UNION ELECTRIC COMPANY

October 3, 1984

ULNRC-938

DOCKET NUMBER 50-483
CALLAWAY PLANT, UNIT 1
REVISION TO TECHNICAL SPECIFICATION 4.6.1.2 AND
3/4.6.1.2 BASES

ATTACHMENT TWO

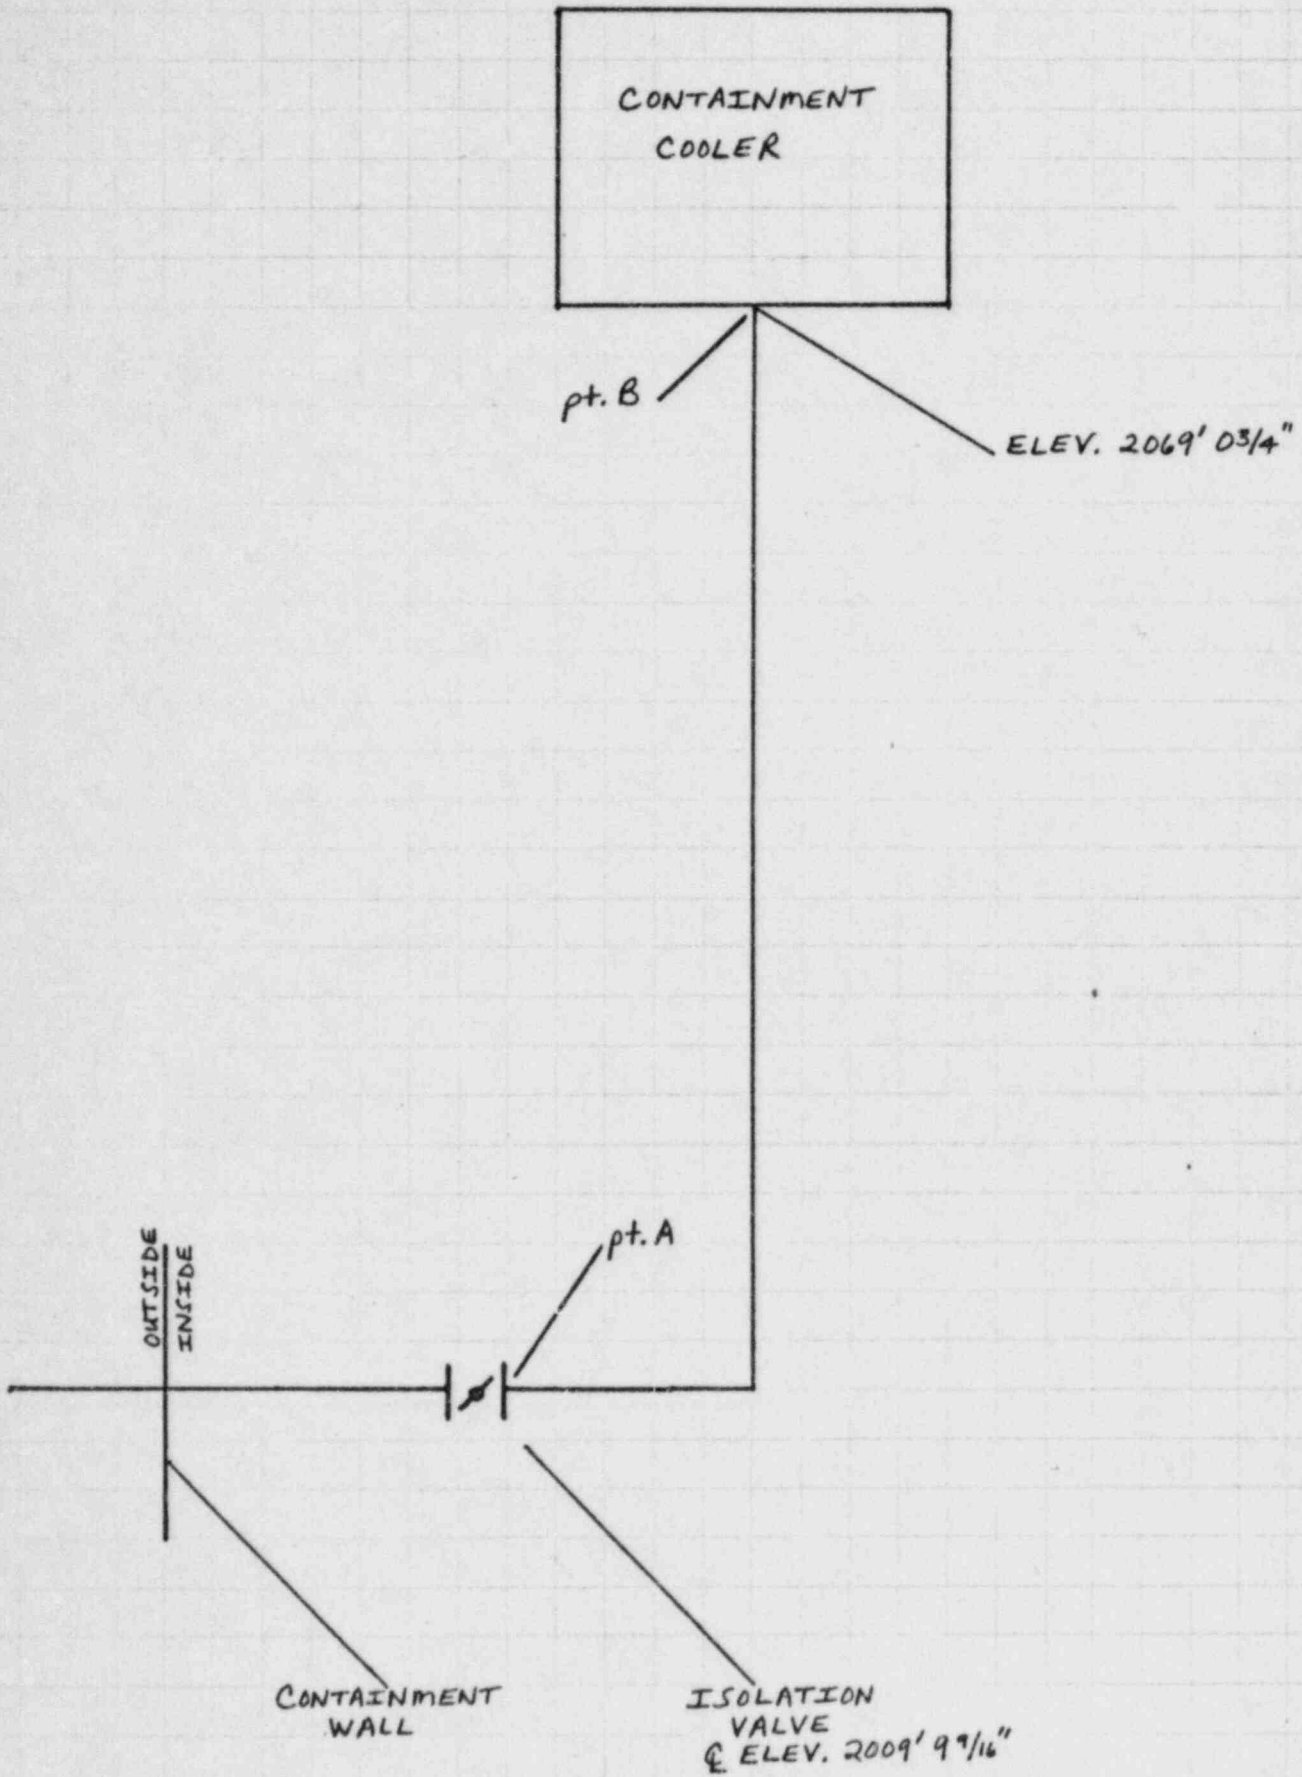
With respect to the system not meeting the precise requirements of a closed system inside containment, the effects of a passive failure are addressed as follows.

Passive failures in ESF systems are postulated during the long term post-accident phase in accordance with FSAR Section 3.1.1 and in accordance with NRC guidelines. When passive failures are postulated in the long term (24 hours), no single active failures need be considered; therefore, the ESW pumps and all valves would be operable. As noted in FSAR Section 3.1.1.4, passive component failures when applied to fluid systems mean abnormal leakage from a single sprung flange, a single pump seal failure, or a single valve stem packing failure, and not from a piping failure. This definition of a passive failure is in agreement with the NRC staff position stated in Issue #7 of NUREG 0138.

The NRC staff has previously accepted the use of water contained in piping systems as seal water systems meeting the intent of Appendix J, Section III.C. This section of Appendix J allows hydrostatic testing of containment isolation valves served by a seal system provided that the valve leakage rates do not exceed Technical Specification limits and that the fluid seal water system inventory is sufficient to assure a sealing function for 30 days. Appendix J does not imply that the seal system is to be pressurized to 1.1 Pa following an accident. The fluid contained in the ESW piping inside containment meets these requirements.

If the SRP criteria are used to determine the allowable leakage rate (assuming a single active failure), there would be no depletion of the contained fluid and the volume would last indefinitely since there would be no air leakage into the system to force the water out. In the case of a credible passive failure (during the long term) of a sprung containment air cooler flange, air leakage into the piping would occur if the ESW pumps were turned off. Turning the pumps off would not be necessary since, in postulating only a passive failure, the containment isolation valves would be operable and the pumps could continue to perform their function. Union Electric is proposing a Technical Specification leakage limit for these valves of 7000 ml/hr when pressurized to 1.10 Pa.

This limit ensures that a 30 day water volume will be available in the piping system. The water volume from the air cooler to the nearest containment isolation valve would be depleted in 30 days if the leakage rate were greater than 7166 ml/hr. It should be noted that the pressure in an isolated air cooler train would approximate the containment atmospheric pressure which would be near atmospheric pressure after 1 day, which is the earliest time a passive failure is postulated. If surveillance testing demonstrated leakage greater than 7000 ml/hr for any of these four valves, then a violation of containment integrity would exist and the ACTION statement of Technical Specification 3.6.1.1 would be entered. Repairs would be effected and the leakage limit satisfied prior to entering mode 4, hot shutdown.
